ADDENDUM NO. ONE
FERNDALÉ PUBLIC SCHOOLS
2017 SINKING FUND PROJECTS
SUMMER 2019 RENOVATION PROJECTS
Page 1 of 2 (write up only)

February 8, 2019

ADDENDUM NO. ONE to the plans and specifications for the FERNDALÉ PUBLIC SCHOOLS, 2017 SINKING FUND PROJECTS, SUMMER 2019 RENOVATION PROJECTS, Ferndale, MI, Architect's Project No. 181794, dated February 1, 2019.

2 WALL SECTION
A1.0LE
SCALE: 1/4" = 1'-0"

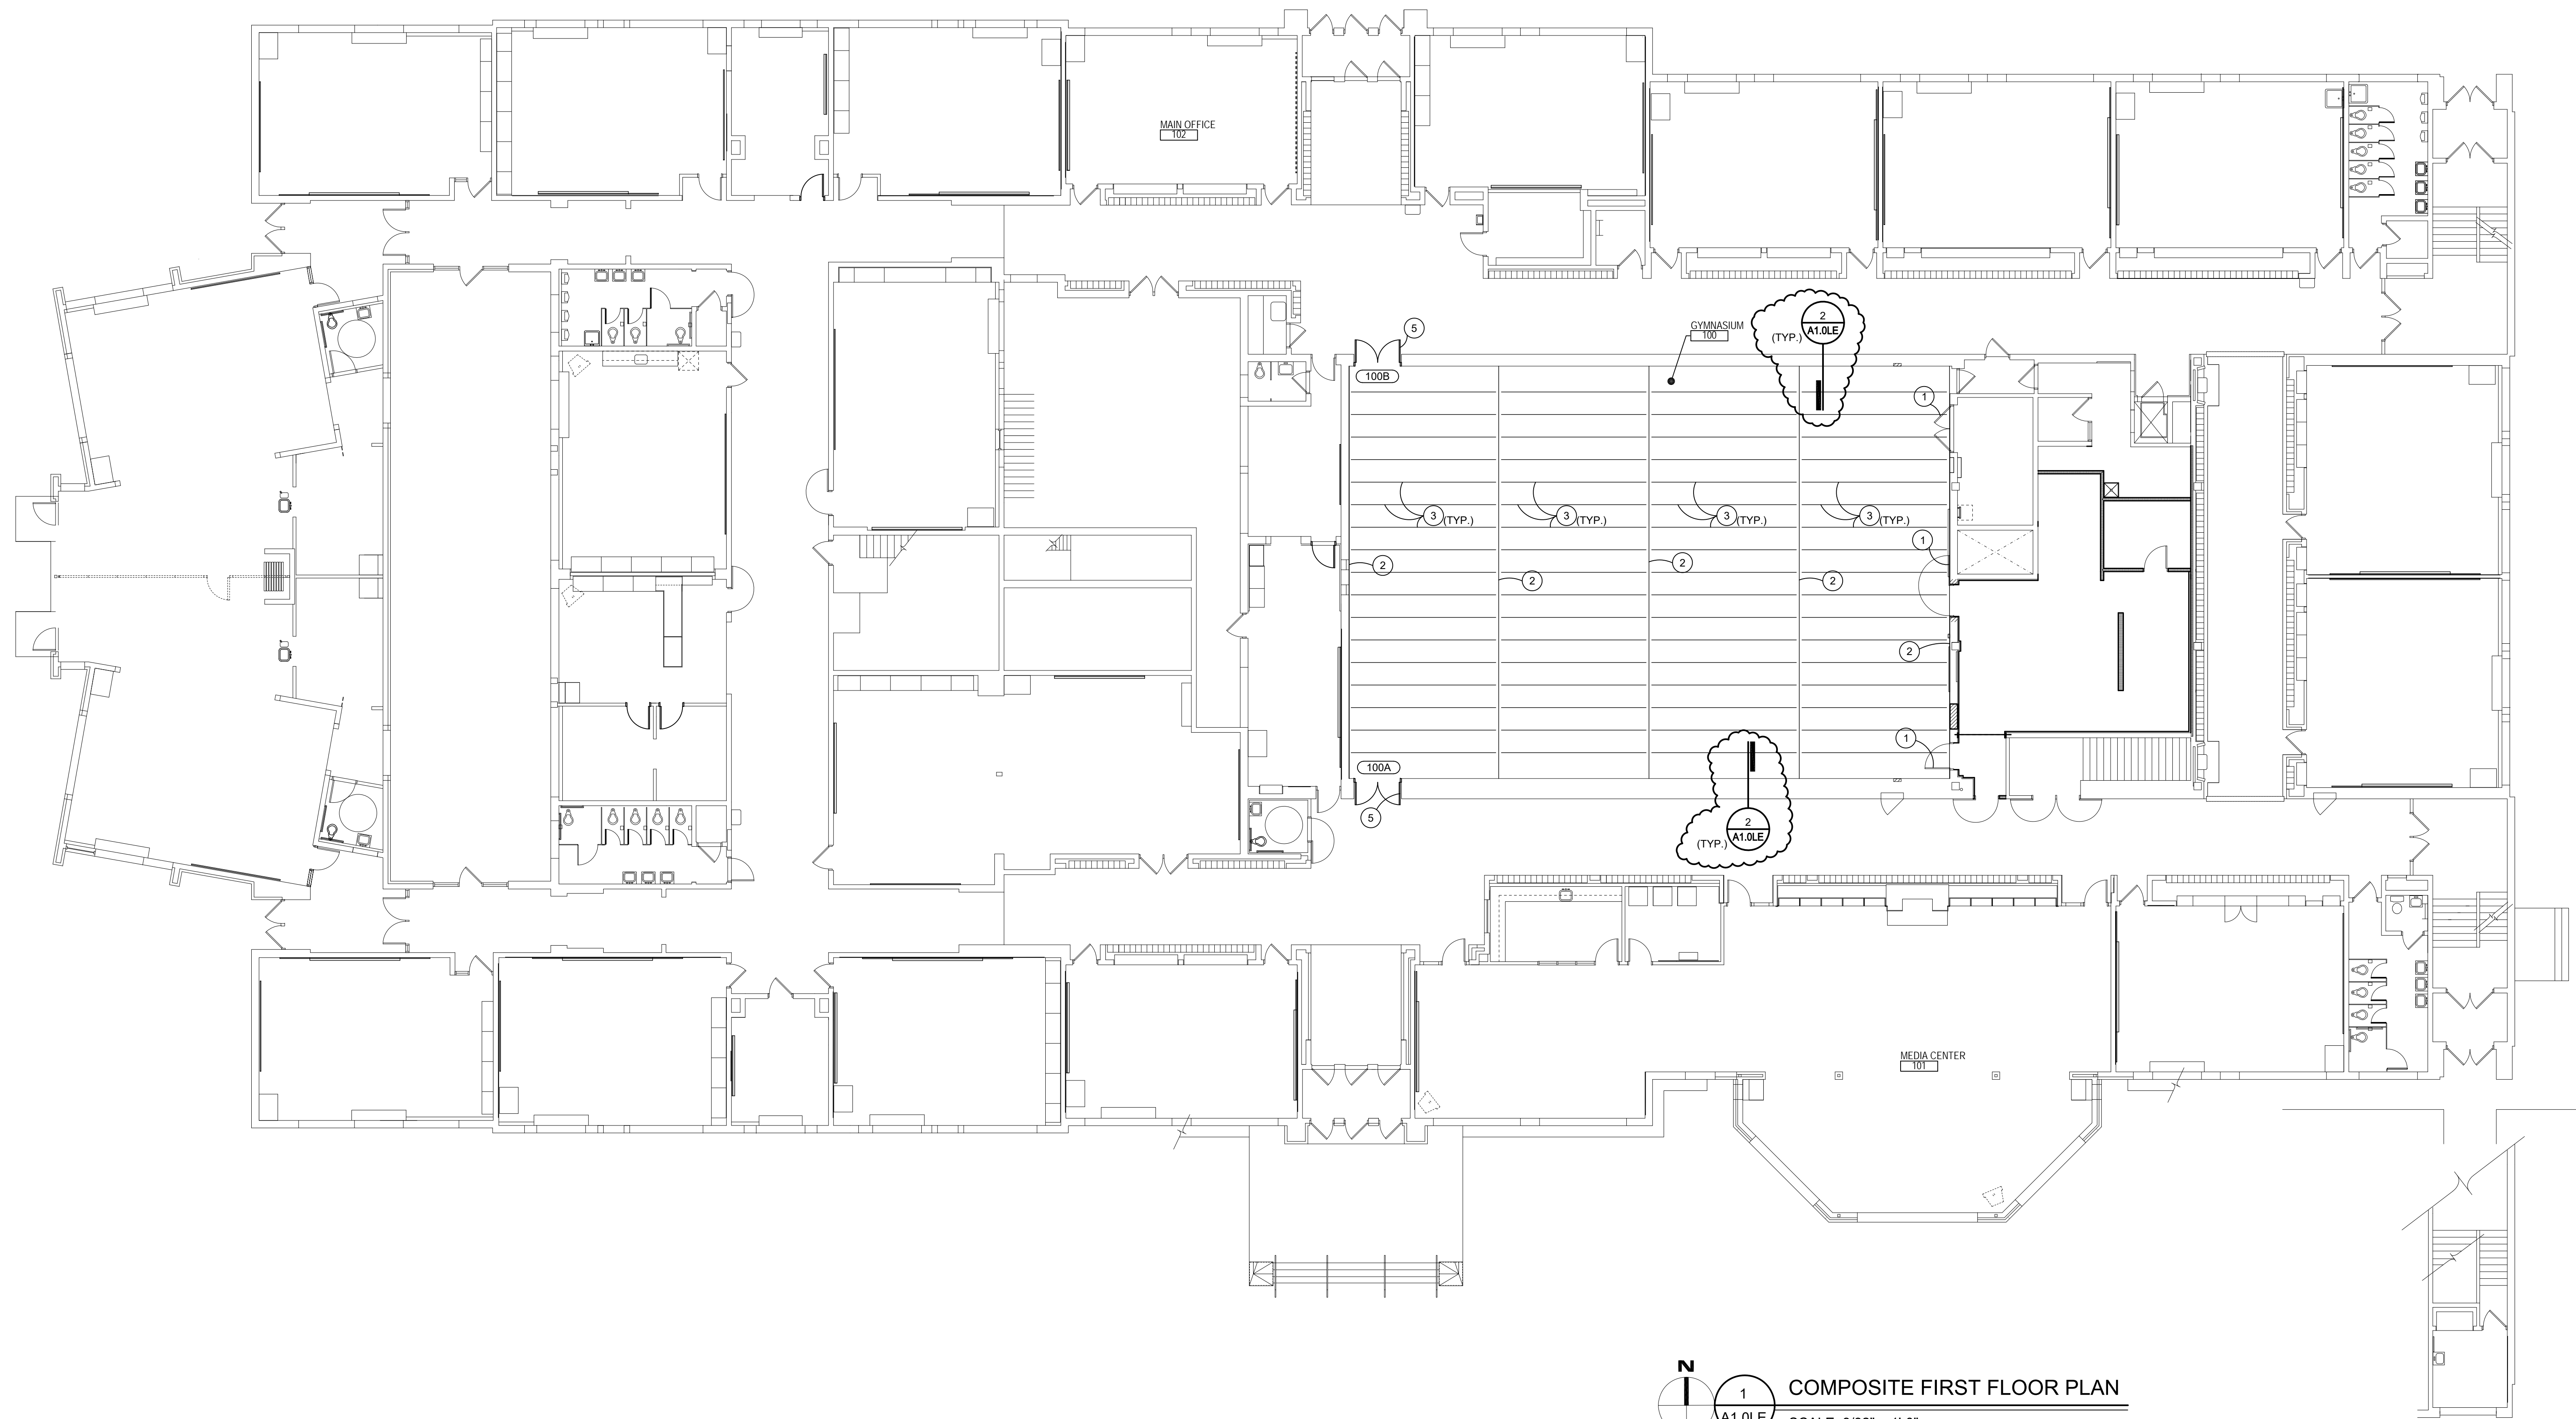
- ITEM NO. A1:** Refer to Drawing No. A1.0LE (re-issued):
- a. Refer to attached drawing no. A1.0LE for the locations of detail no. 2.
- ITEM NO. A2:** Refer to Drawing No. A1.0UE (re-issued):
- a. Refer to attached drawing no. A1.0UE for revised note no. 1.
- ITEM NO. A3:** Refer to Drawing No. A1.1UH (re-issued):
- a. Refer to attached drawing no. A1.1UH for location of typical detail no. 2.
- ITEM NO. A4:** Refer to Drawing No. A1.0H (re-issued):
- a. Refer to attached drawing no. A1.0H for revised New Work Note 29.
